4 Project changes and design refinements

The EIS for the project was prepared based on a concept project design (refer Chapter 5 of the EIS). This design has since been refined to account for design changes and in response to submissions received during exhibition of the EIS.

The Northern Road upgrade -
Mersey Road to Glenmore Parkway
**Construction Boundary and
Compound Sites**

Figure 4-3 | Comparison of EIS and refined design operational footprints

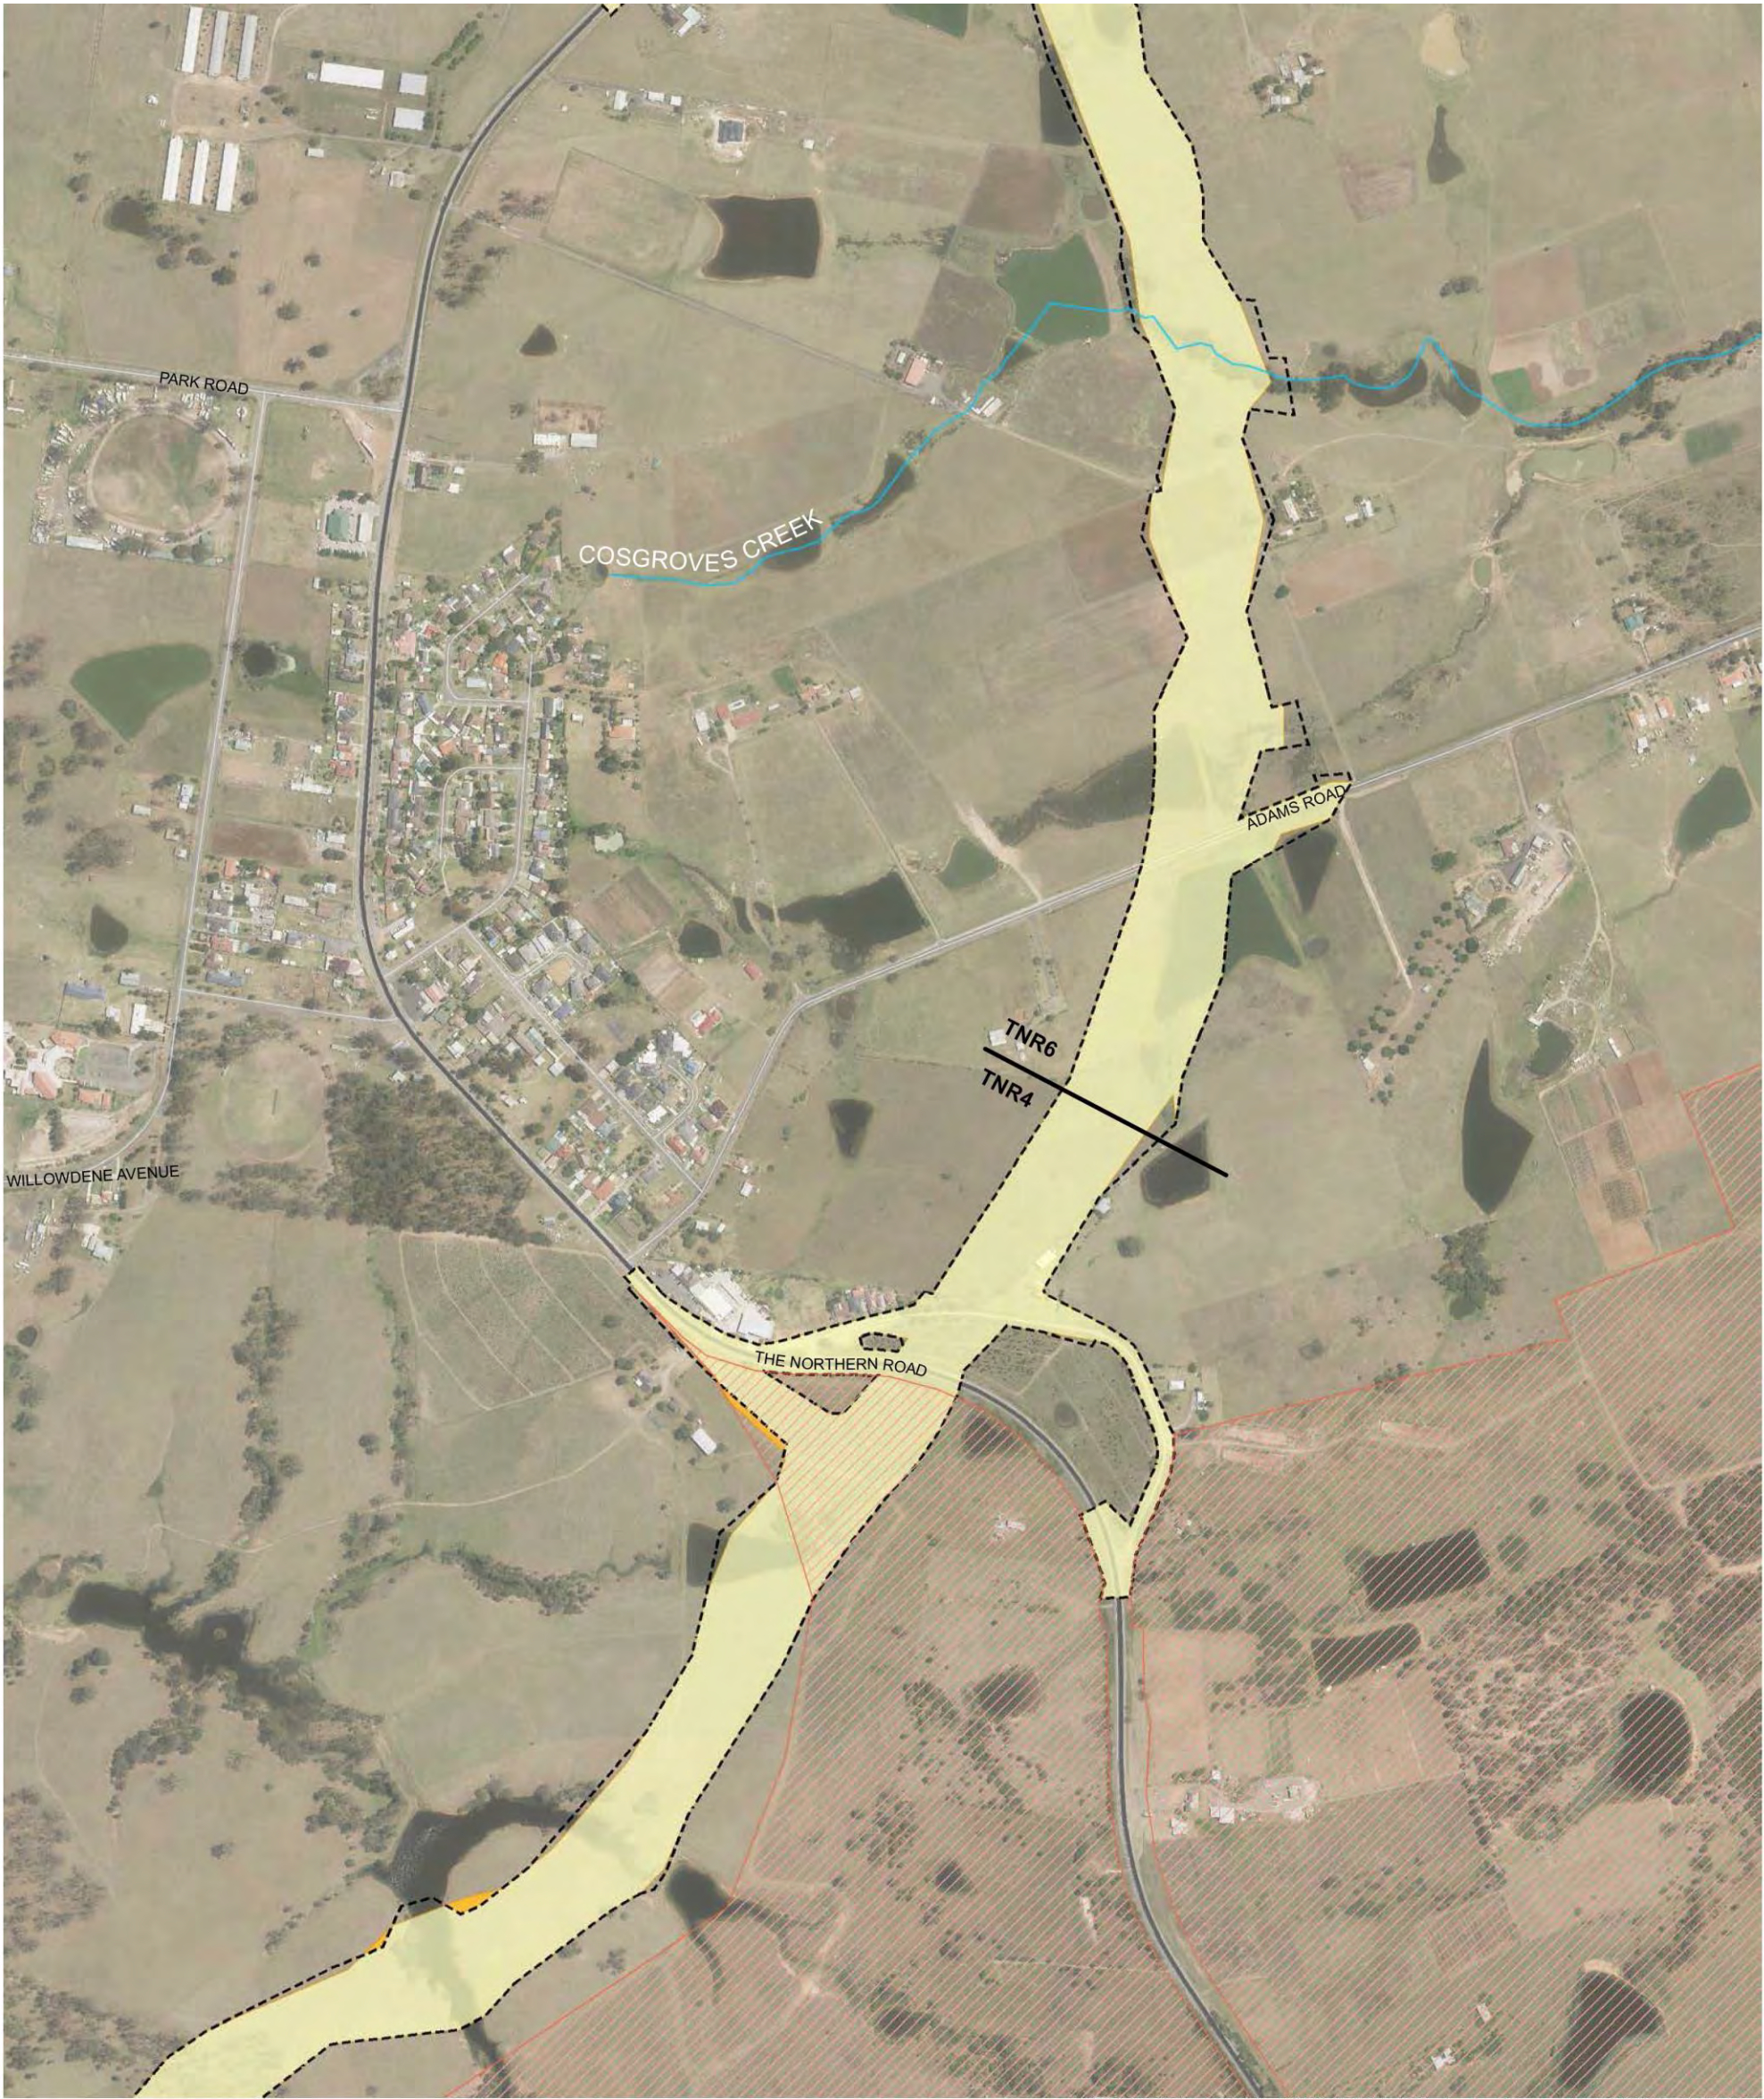
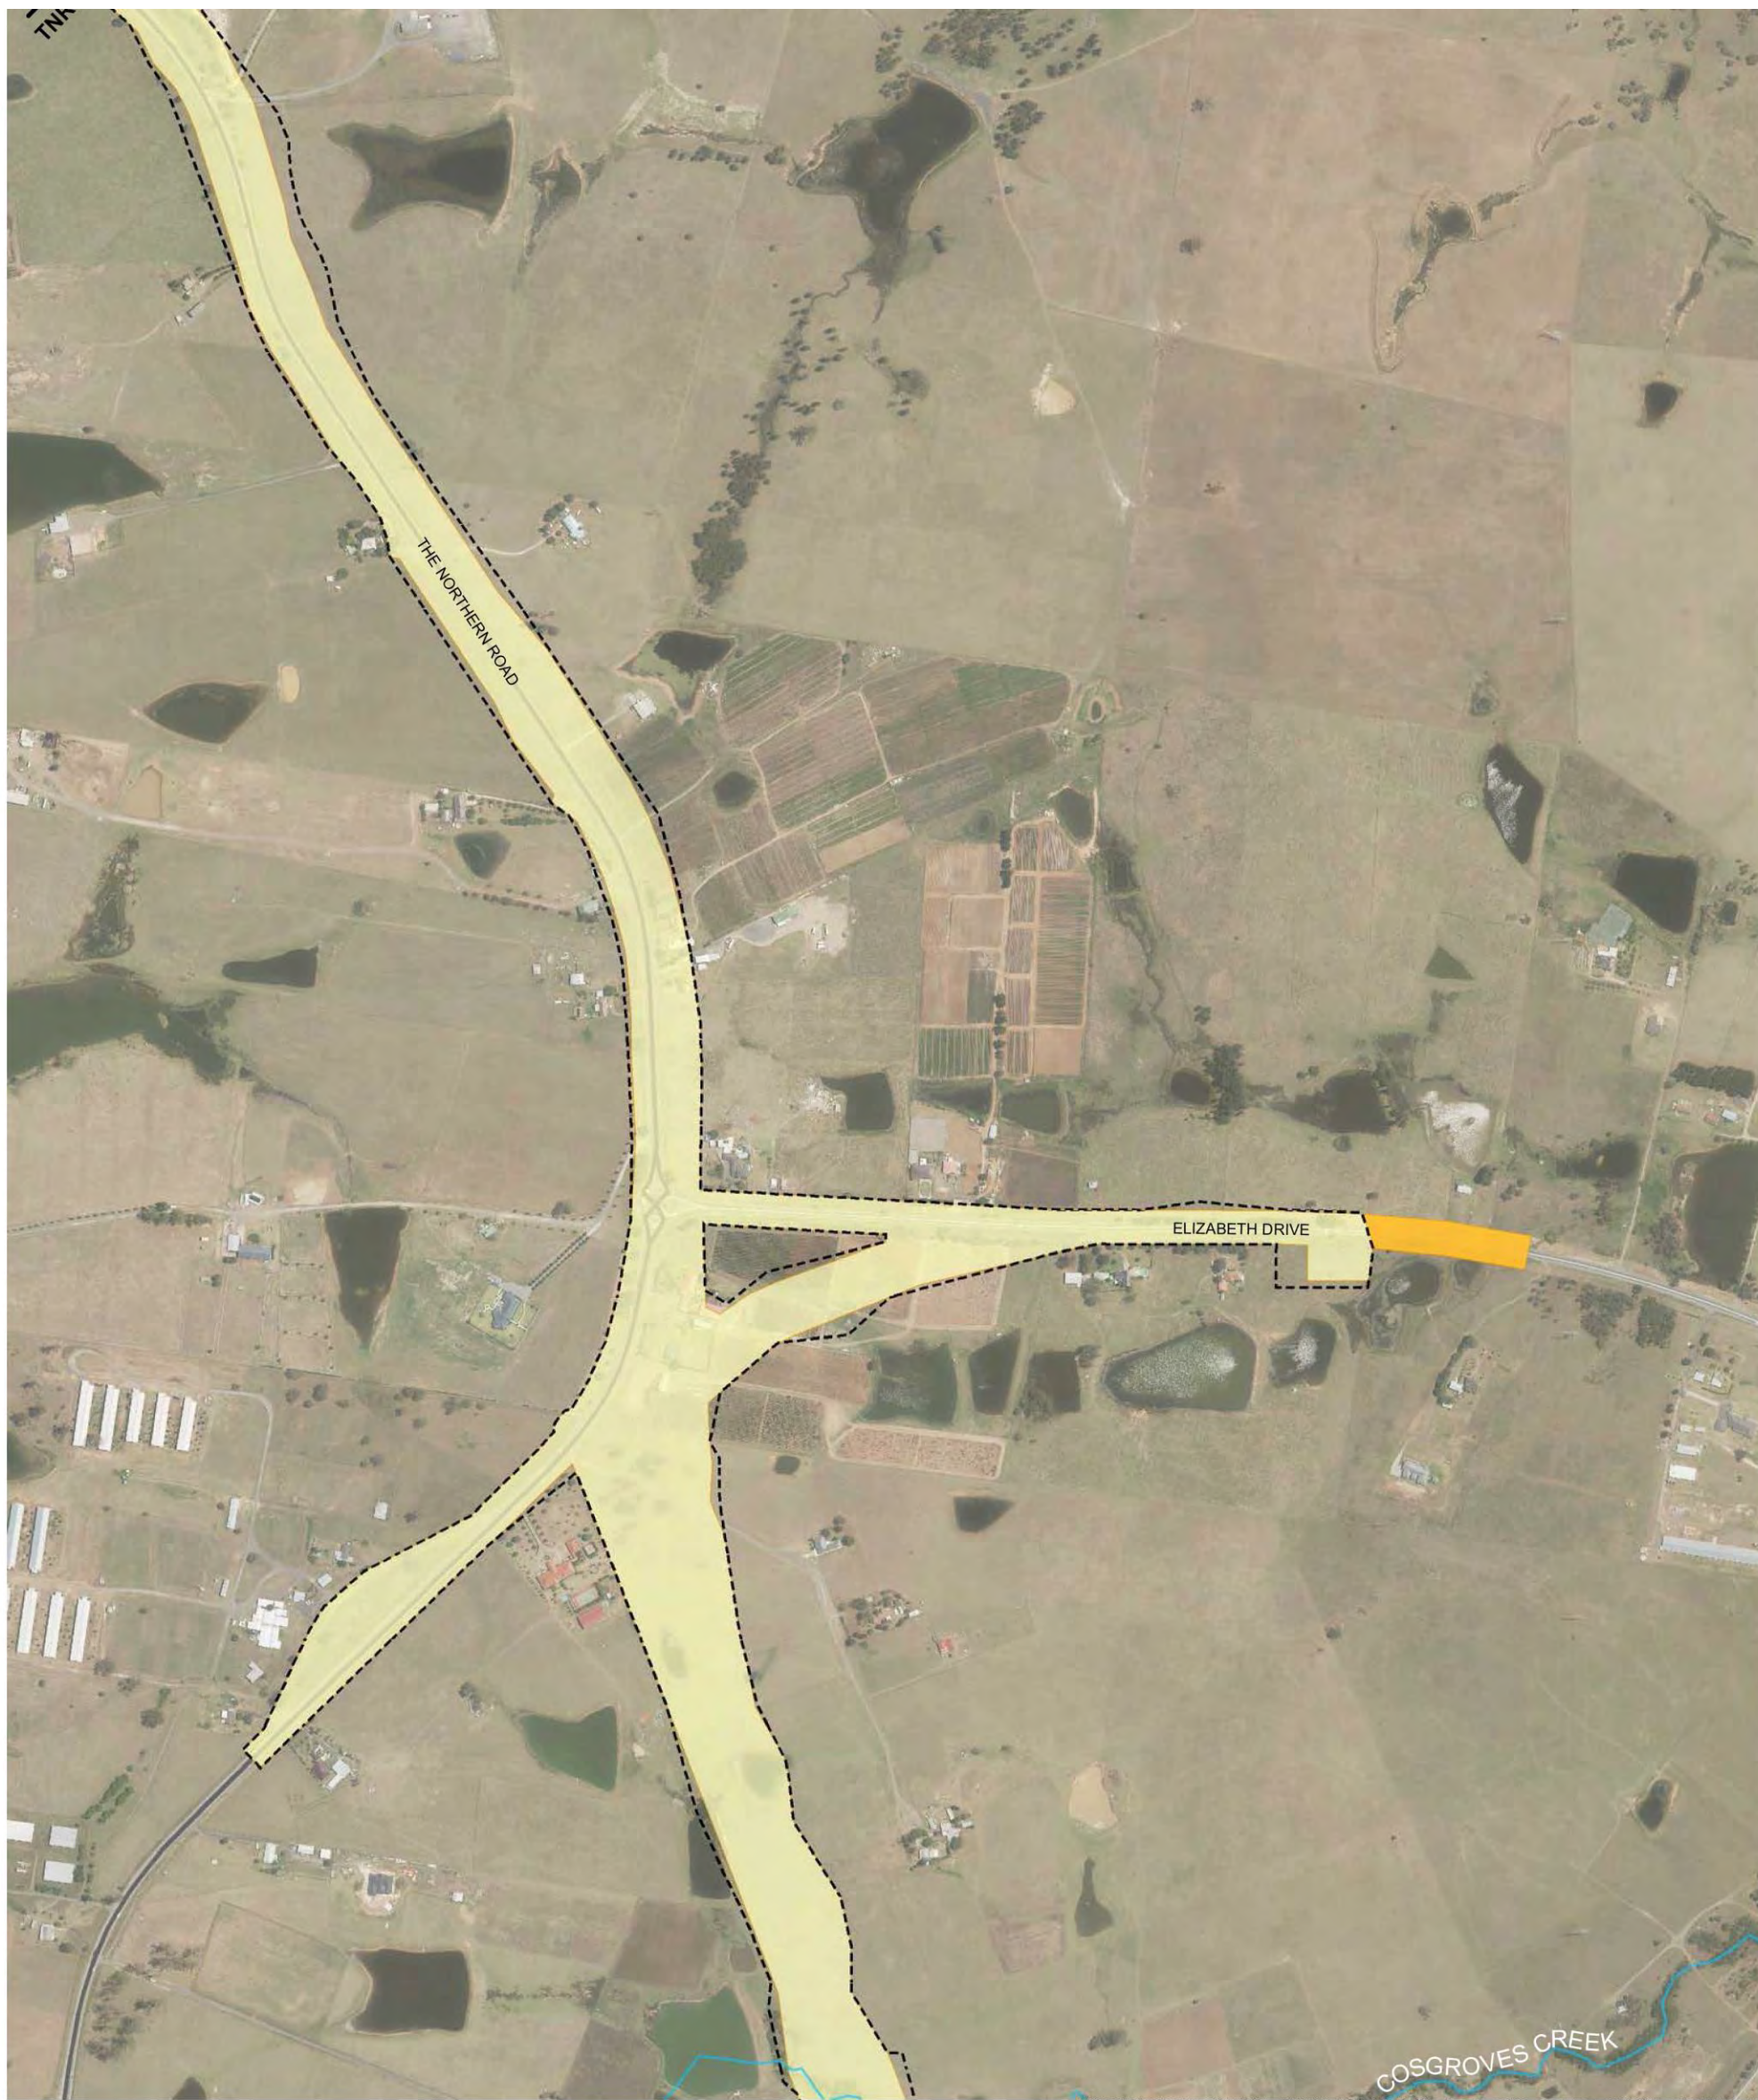
Table 4-2 provides a comparison of the construction and operational footprints calculated for the design refinements against the footprints assessed in the EIS, with reductions of 10 ha and 16 ha identified respectively. An error in the EIS footprint calculations (EIS – original) was identified during the footprint assessment which has been corrected in the table (EIS – revised).

Figure 4-2 provides a comparison of the EIS and the refined design construction footprints. Figure 4-3 provides a comparison of the EIS and the refined design operational footprints.
